**Randolph Pump Station Improvements Project**  
**Solicitation Number: CO-00459**  
**Job No.: 20-8611**

**ADDENDUM NO. 5**  
**January 13, 2023**

1 PLUMBING FLOOR PLAN  
1/4" = 1'-0"

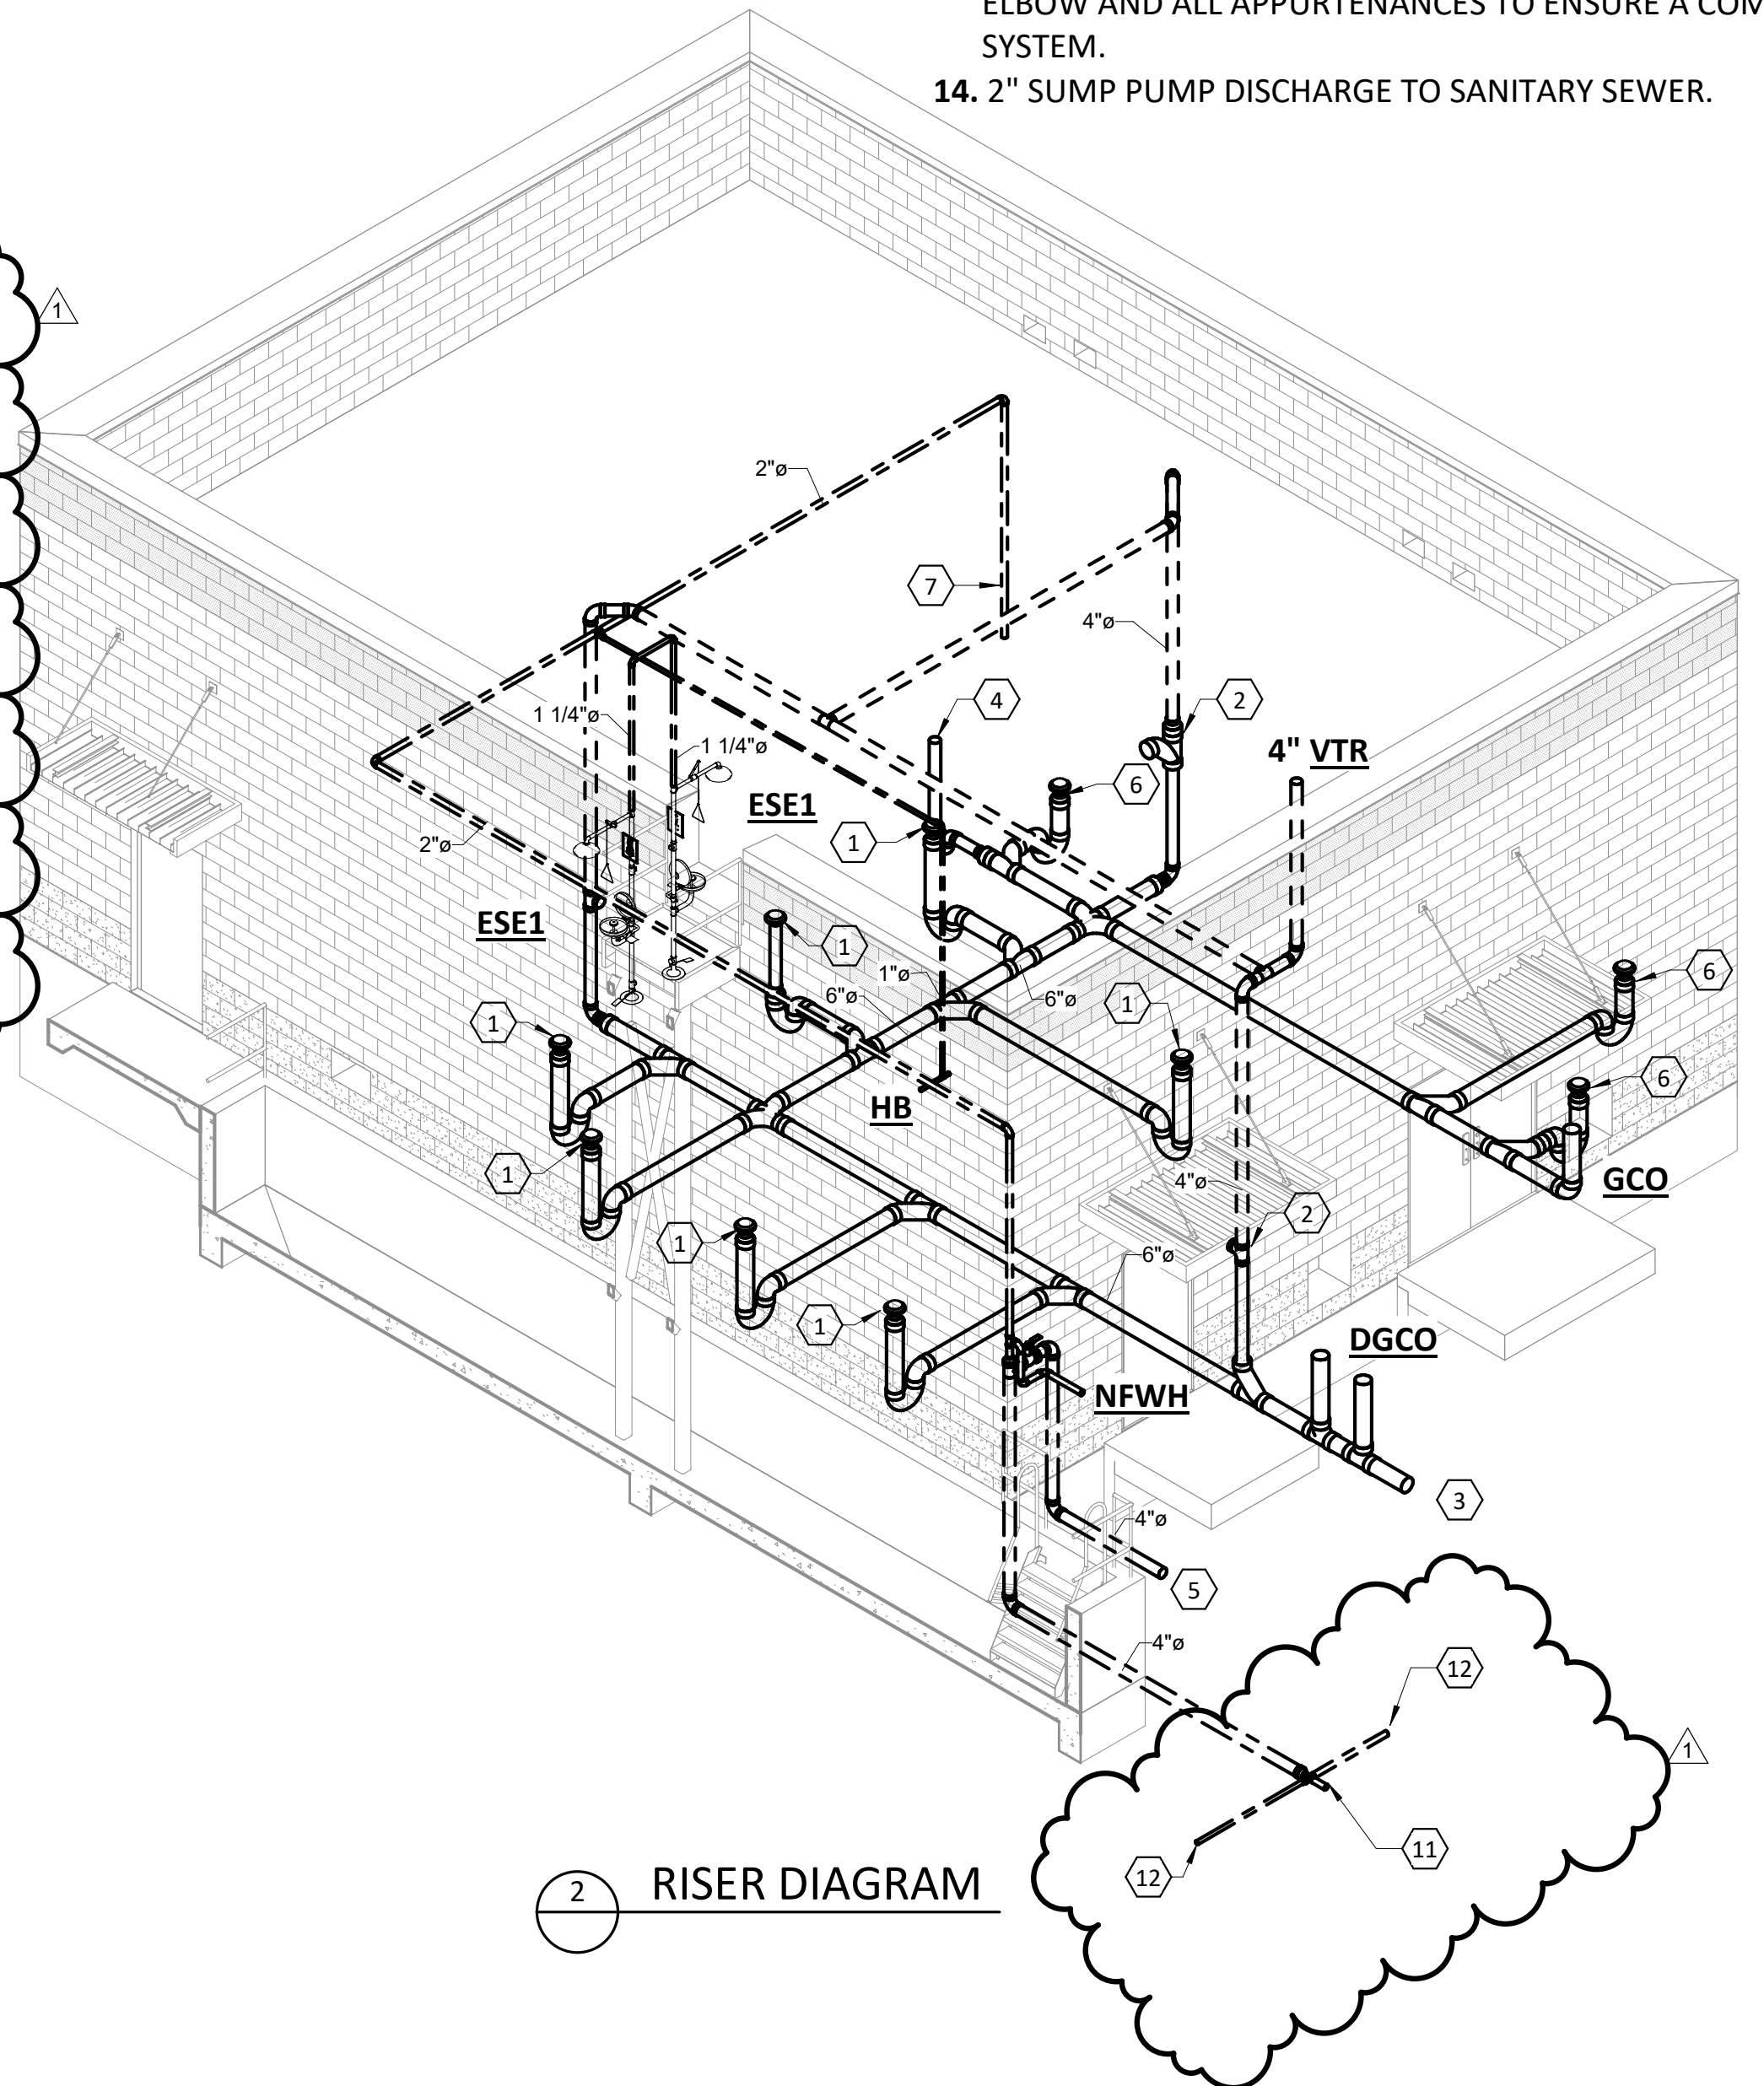
- 65. Question:** Reference sheet PL-4, drawing 1&2 show the domestic water line as 4". Reference sheet PL-4, note 11 calls the line 2" and to be routed to the fluoride building; note 12 calls the line 1-1/4" and to be routed to ESE2. Please clarify the correct pipe size and intended destination.  
*Response:* PL-4 has been updated to address discrepancy. See Item No. 11 in the CHANGES TO THE PLANS section in this addendum.

**Delete** Sheet PL-4 in its entirety **and replace with** revised Sheet PL-4 included in this addendum.
- 12. Sheet E-4 Site Layout – Modification**  
**Delete** Sheet E-4 in its entirety **and replace with** revised Sheet E-4 included in this addendum.

SAN ANTONIO WATER SYSTEM  
**RANDOLPH PUMP STATION IMPROVEMENTS**  
ELECTRICAL  
**SITE LAYOUT - MODIFICATION**

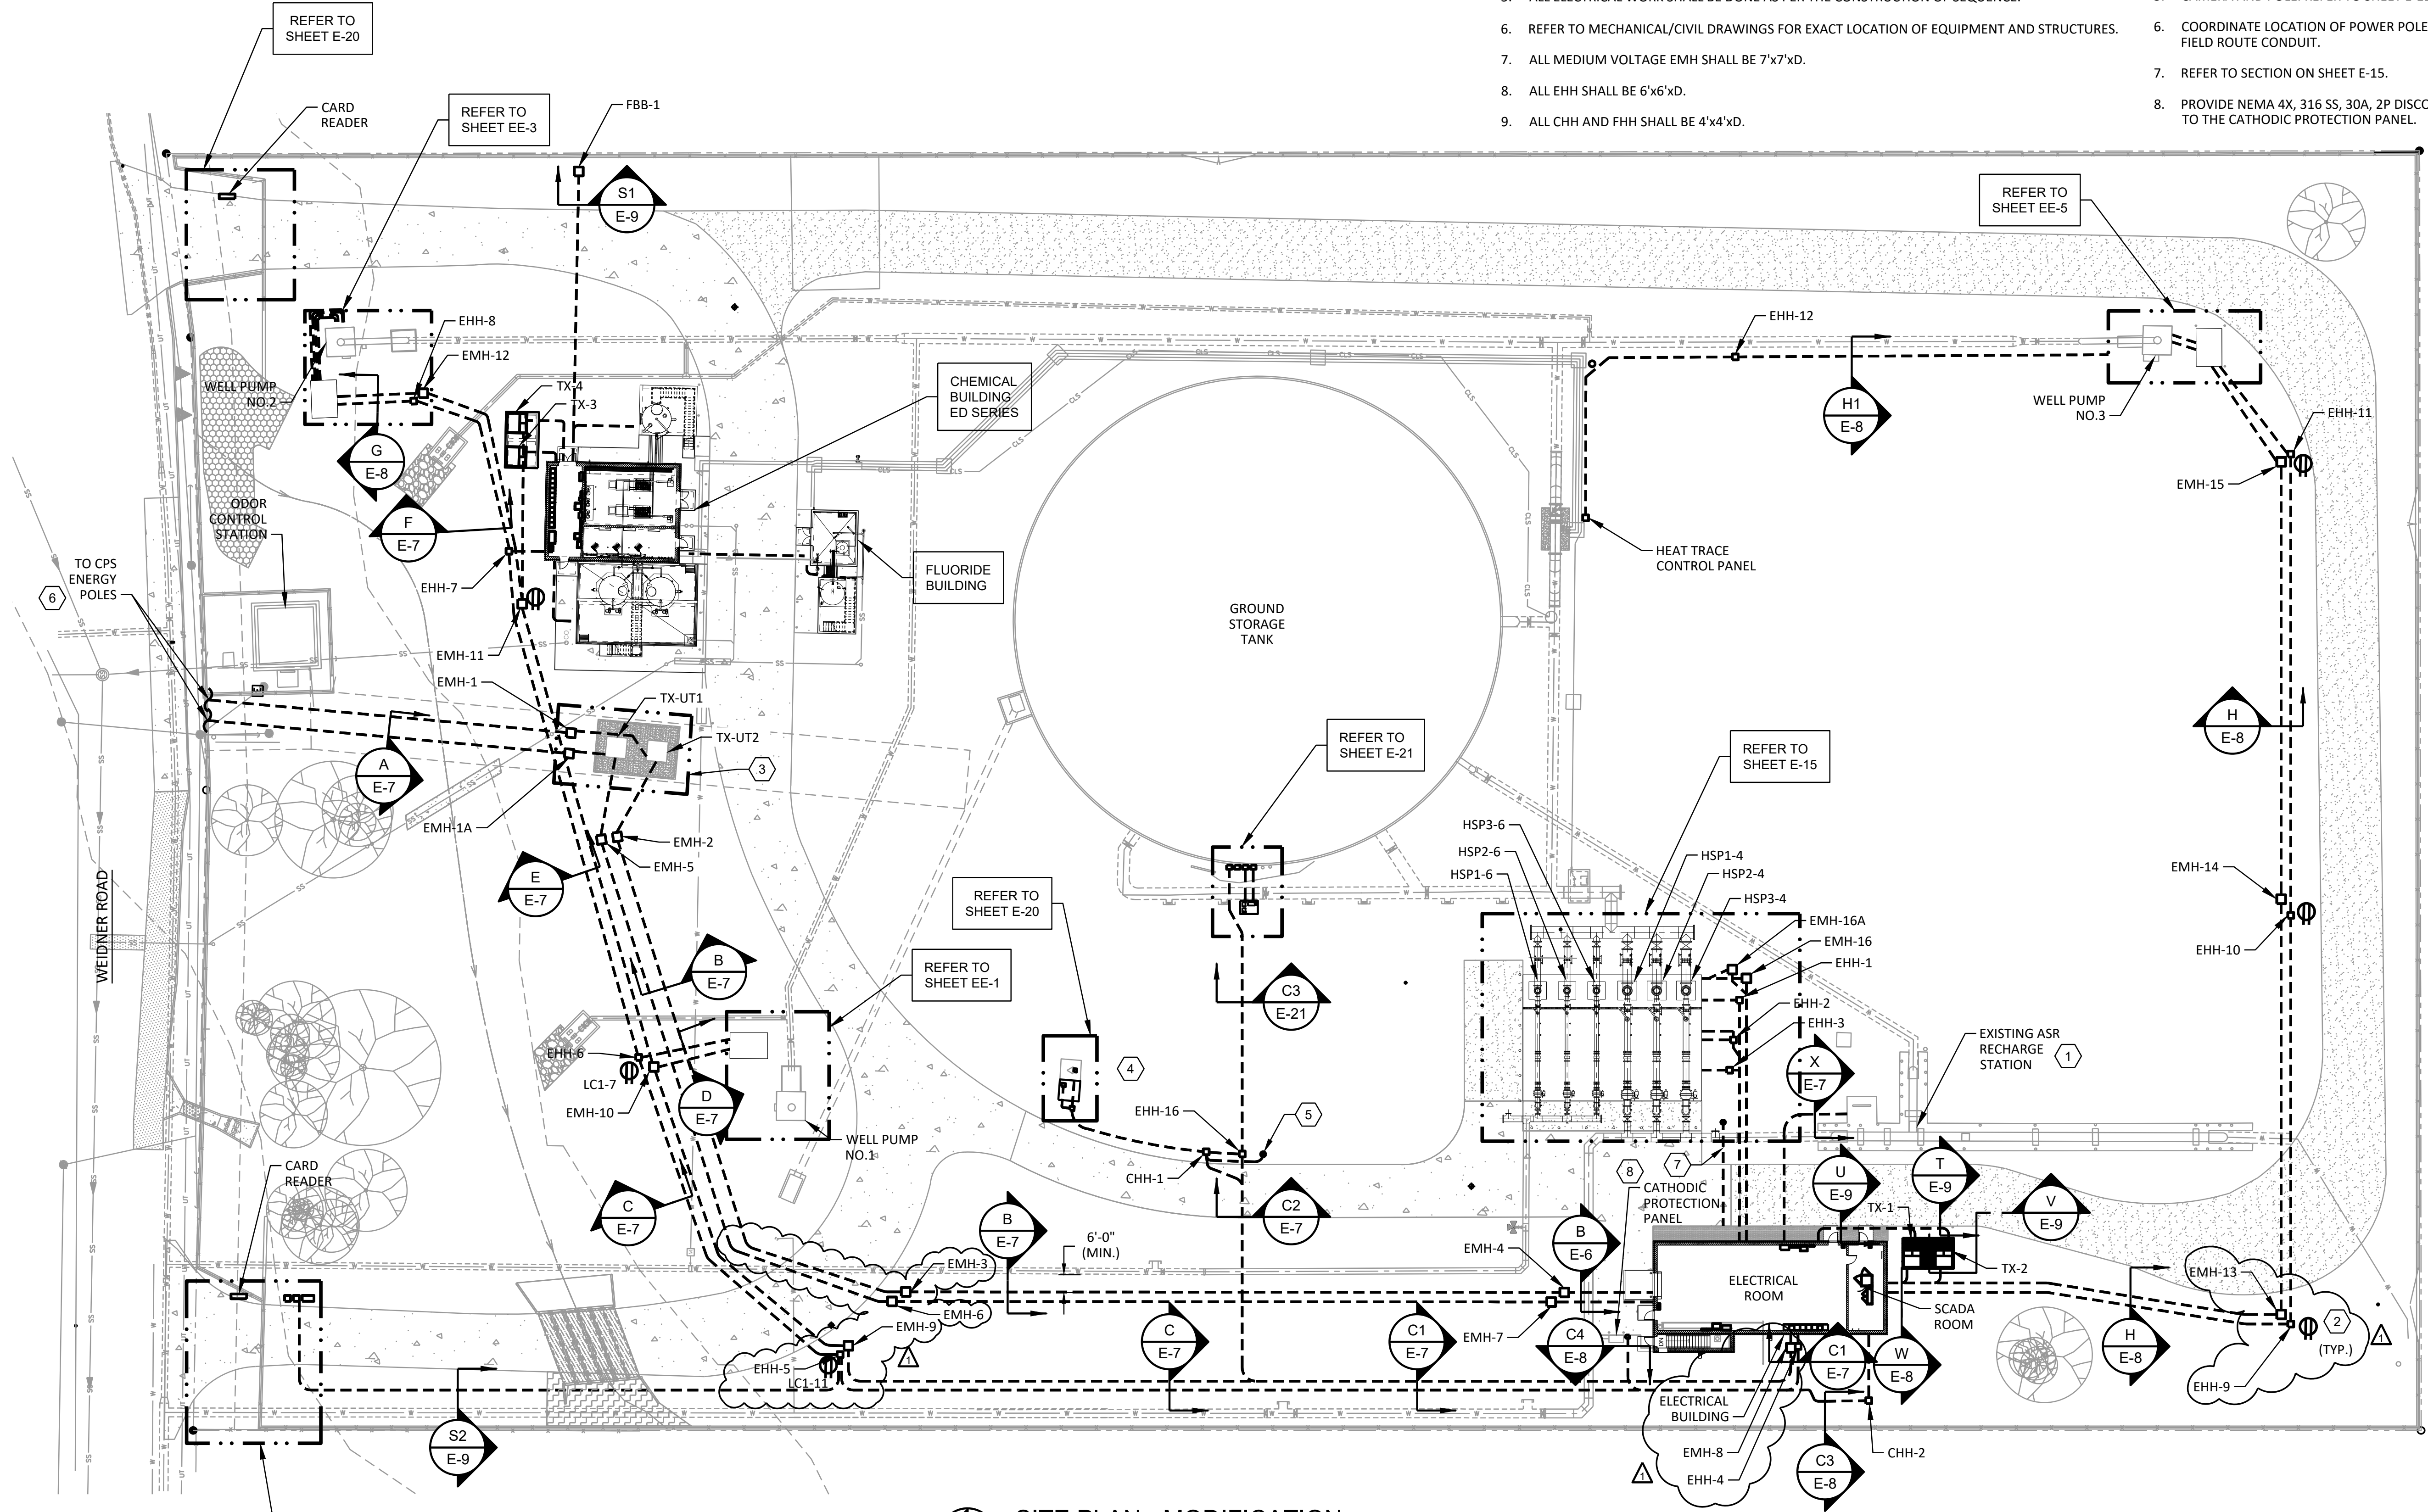
- 13. Sheet E-5, Site Lighting Plan**
  - a. Move** electrical manholes EMH-3 and EMH-6 as modified on Drawing E-4 included in this addendum.
  - b. Move** electrical manholes EMH-9 and EHH-5 as modified on Drawing E-4 included in this addendum.

- c. Move** electrical manholes EMH-8 and EHH-4 as modified on Drawing E-4 included in this addendum.
  - d. Move** electrical manholes EMH-13 and EHH-9 as modified on Drawing E-4 included in this addendum.

14. **Sheet E-6, Site Security Plan**
  - a. **Move** electrical manholes EMH-3 and EMH-6 as modified on Drawing E-4 included in this addendum.
  - b. **Move** electrical manholes EMH-9 and EHH-5 as modified on Drawing E-4 included in this addendum.
  - c. **Move** electrical manholes EMH-8 and EHH-4 as modified on Drawing E-4 included in this addendum.
  - d. **Move** electrical manholes EMH-13 and EHH-9 as modified on Drawing E-4 included in this addendum.

1  
E-21  
-  
ANALYZER PAD DETAIL  
NTS

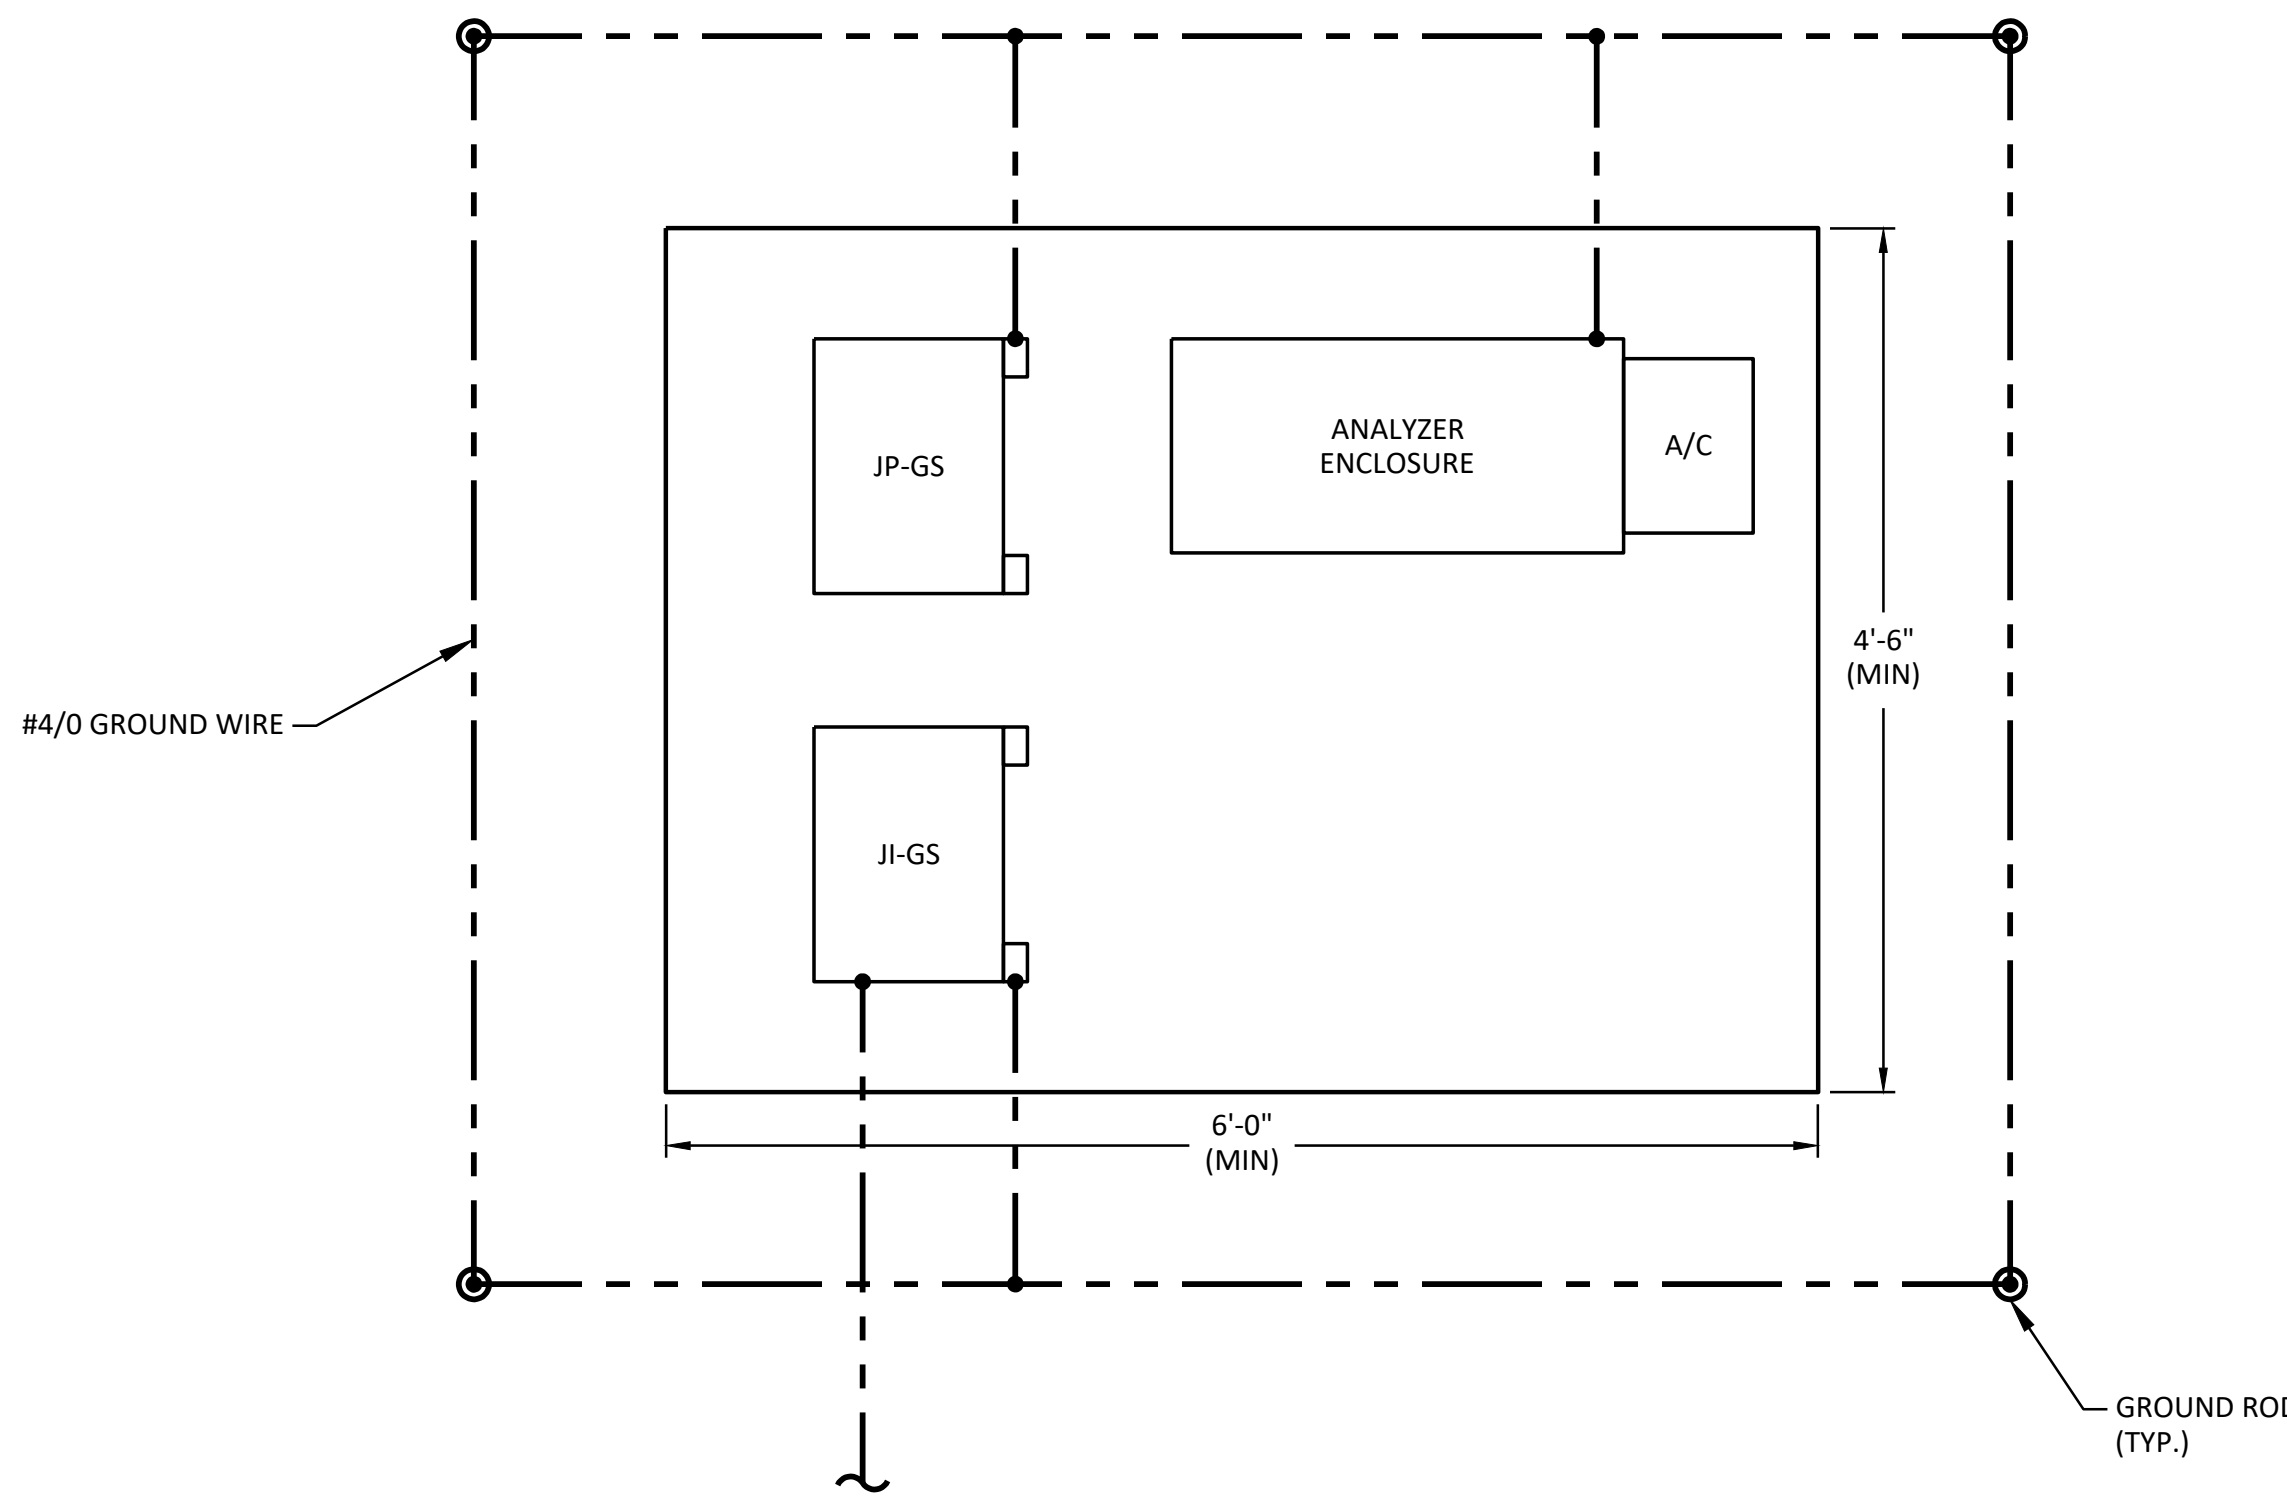
- 14. Question: Contract Drawing C-7 shows that the proposed chemical analyzer station is on sheet E-21 and the detail on sheet EA-6, which only indicates dimensions not the detail for the Concrete Pad. Can you provide or refer to one.**  
*Response: Detail 6 on Sheet S-18 for Exterior Equipment Pads should be used for structural information alongside the dimensional information provided on EA-6.*

17. **Sheet EA-6 Load Summary**  
**Delete** Sheet EA-6 in its entirety **and replace with** revised Sheet EA-6 included in this addendum.
